Seismic Provisions for Structural Steel Buildings (1997) Supplement No. 1

February 15, 1999

Fig. C-13.2. Brace-to-gusset plate requirement for buckling out-of-plane bracing system.

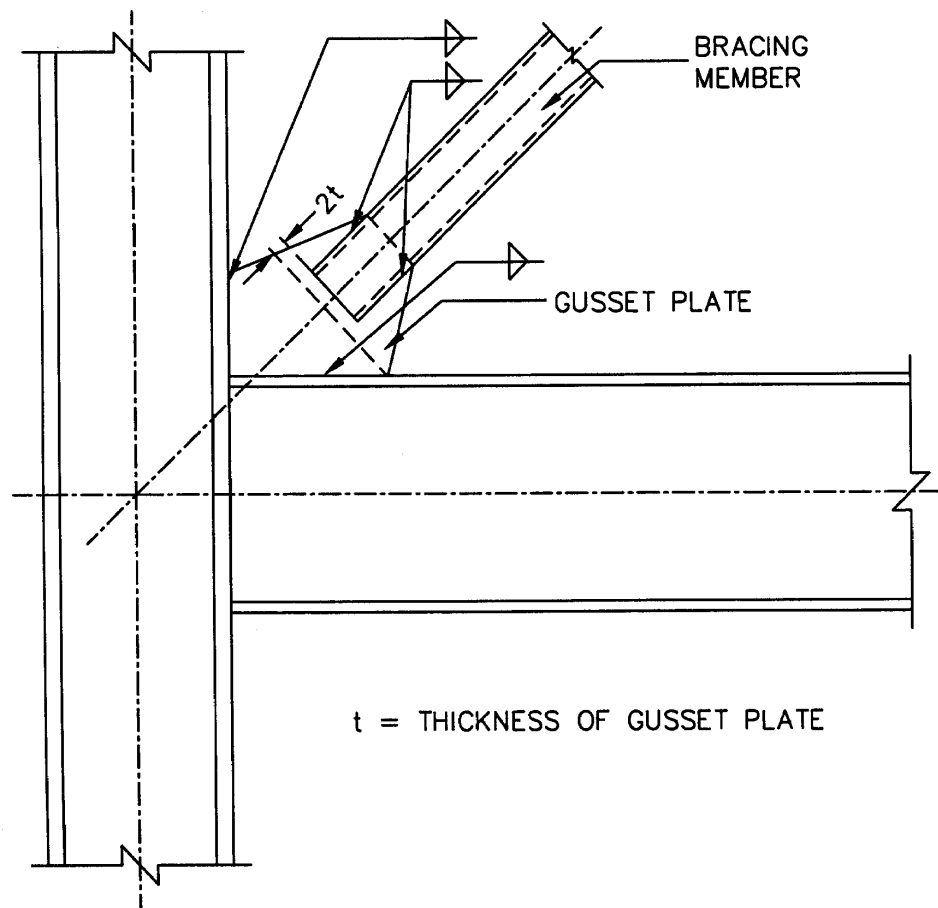
17. Commentary Figure C-13.2

Replace the existing Figure C-13.2 with the attached Figure C-13.2.
